PEDESTRIAN BRIDGE OVER CLARENDON BROOK

PROJECT: WEST RUTLAND
PROJECT NO.: ST. WALK (II)
PEDESTRIAN BRIDGE OVER CLARENDON BROOK
HIGHWAY NO.: CLARENDON AVE.
TOWN OF WEST RUTLAND

PLAIN ELASTOMERIC BEARINGS

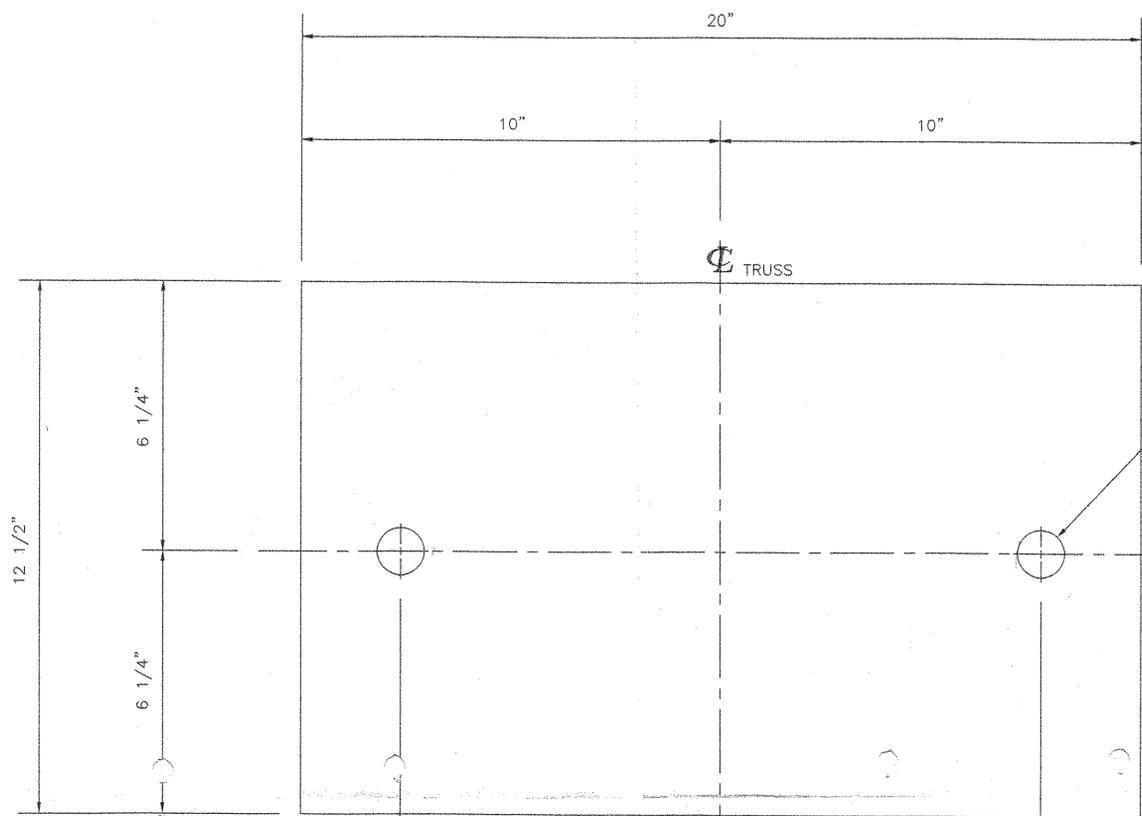
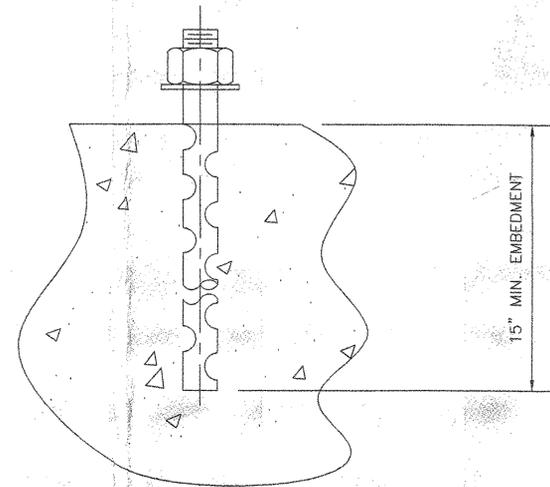
Field verified by Contractor
Changes in red as submitted by fabricator. Okay if field verified.

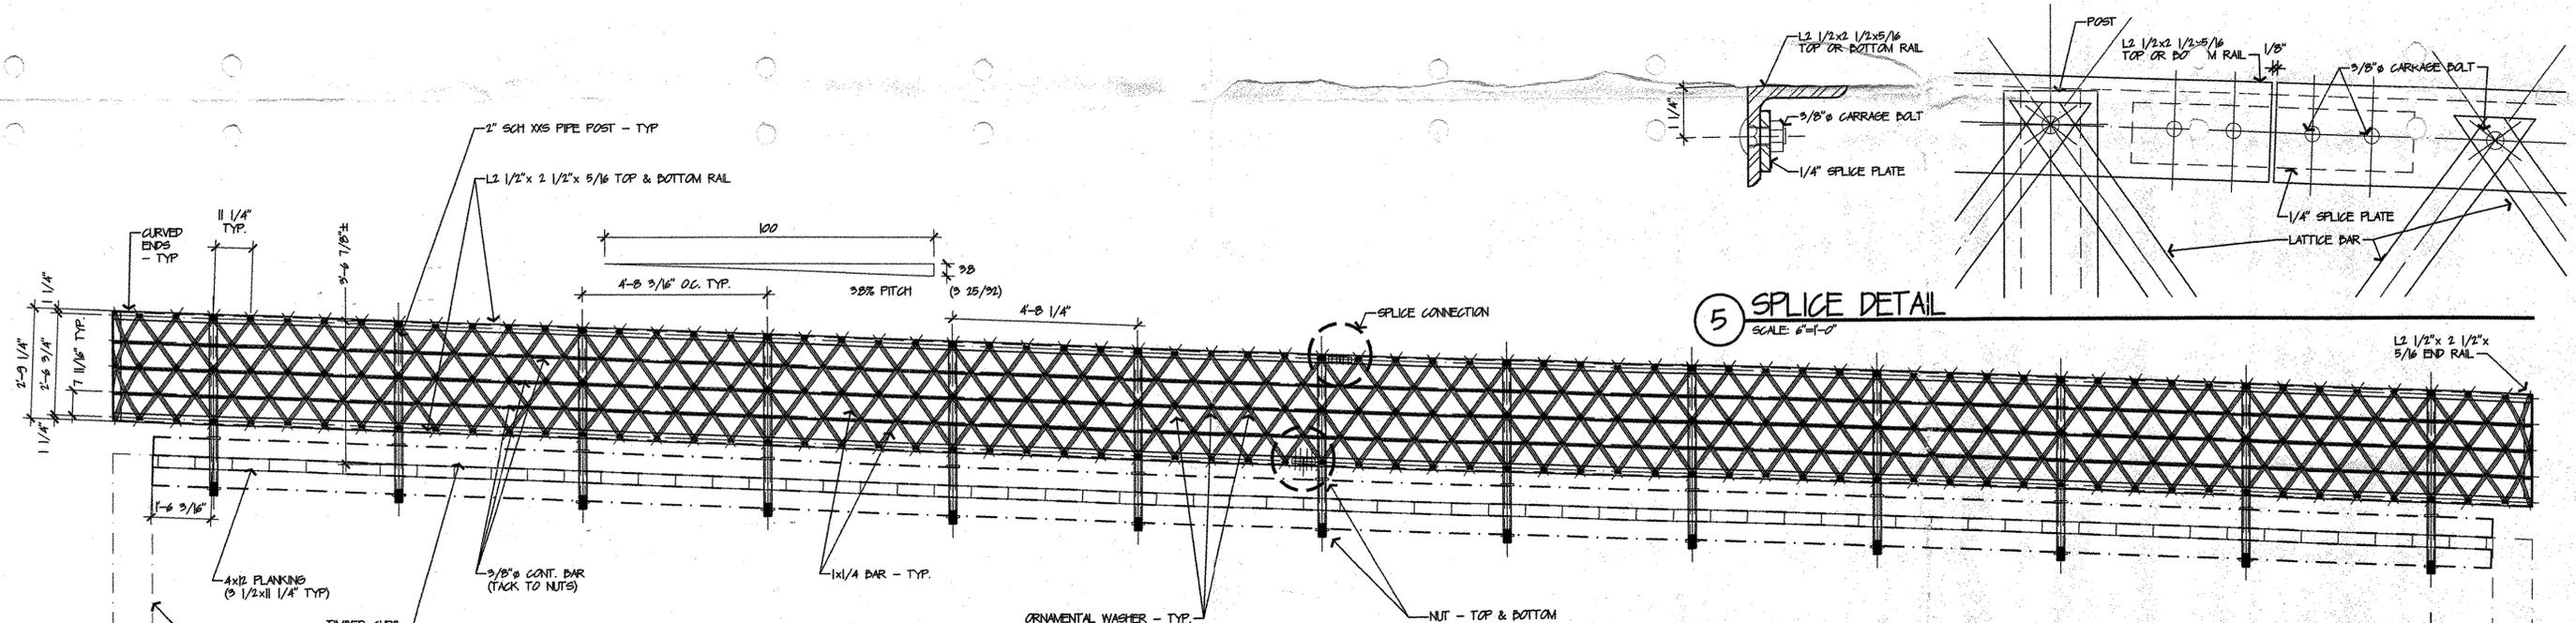
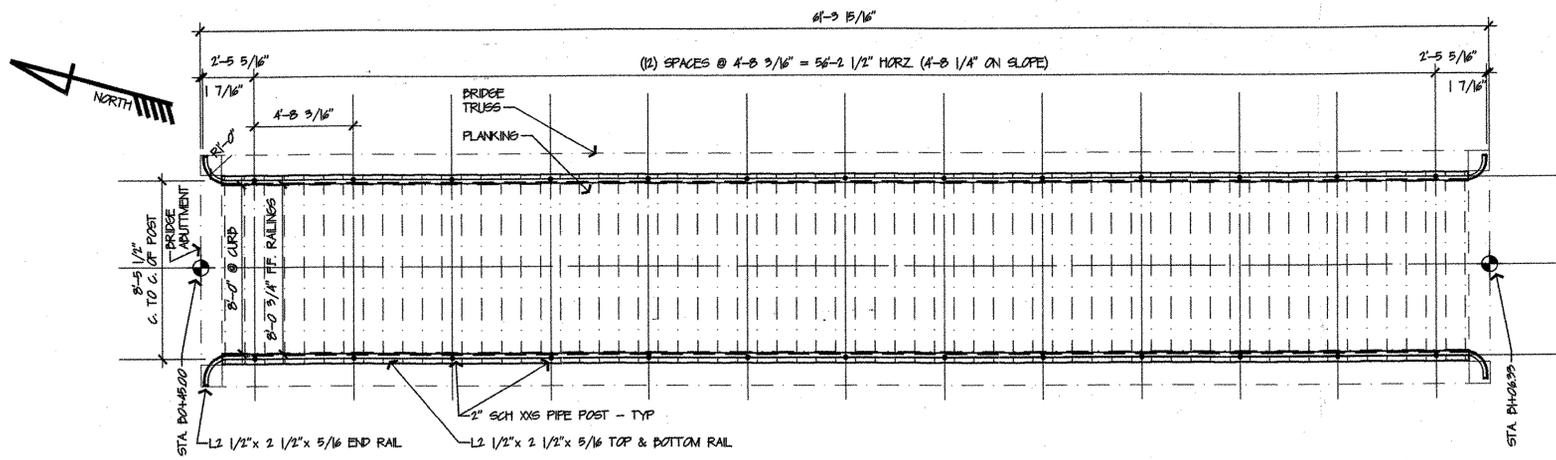
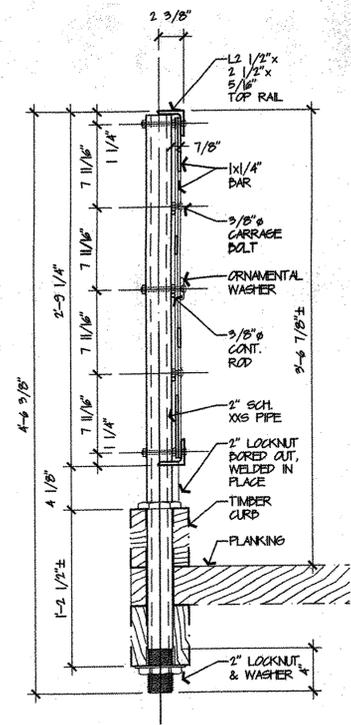
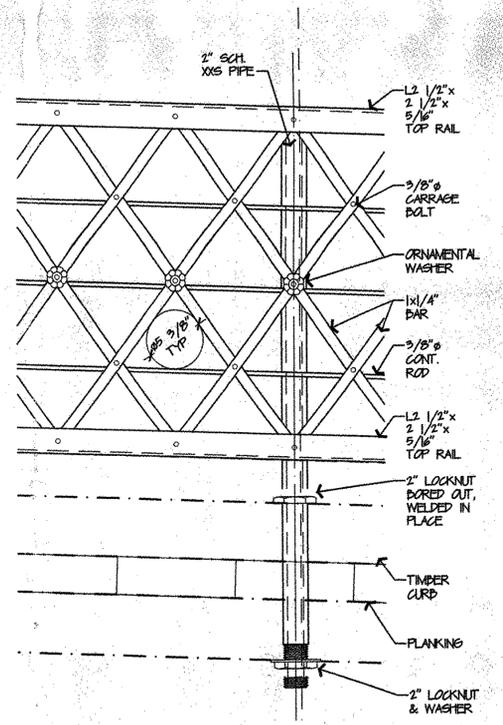
RECEIVED
 OK'D BY *[Signature]* OK'D BY *[Signature]*
 AUG 14 2003
 RESUBMIT APPROVED WITH CHANGES
 BY *[Signature]* DATE 8/26/03 NOTED IN RED
